ADDENDUM 2 OF 2  
**Invitation to Bid: Akins Blvd. Extension**  
June 02, 2022 @ 3:00 PM EST  
City of Statesboro Central Services Purchasing Office  
22 West Grady Street, Statesboro, GA 30458

RE: **Addendum No. 2**  
Akins Boulevard Extension  
Georgia Southern University, Statesboro, GA

The following items clarify, add to, delete from and/ or otherwise change and supersede the information previously issued as Bid Documents for the above referenced project, and shall be acknowledged as **Addendum No. 2** in your bid submittal.

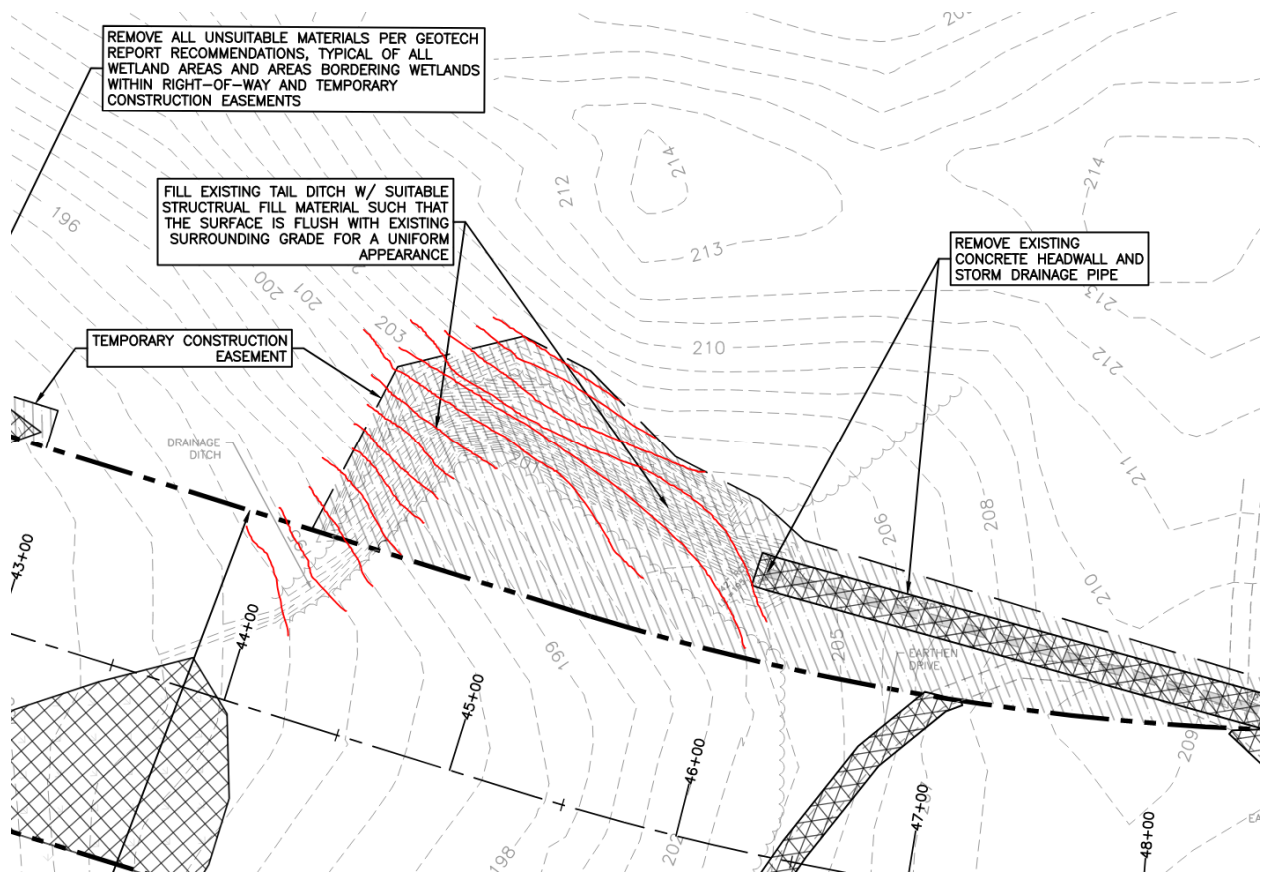
- 5. Question:** Can you define the final elevation you are looking for the tailditch on page C2.2 to be filled to?

**Response:** As noted on plan sheet C2.2: "Fill existing tail ditch w/ suitable structural fill material such that the surface is flush with existing surrounding grade for a uniform appearance". The top of the filled tail ditch just needs to conform to the surrounding grade so that a surface depression or hump is not visible; generally connect the existing contours on either side of the tail ditch like the screenshot image below.
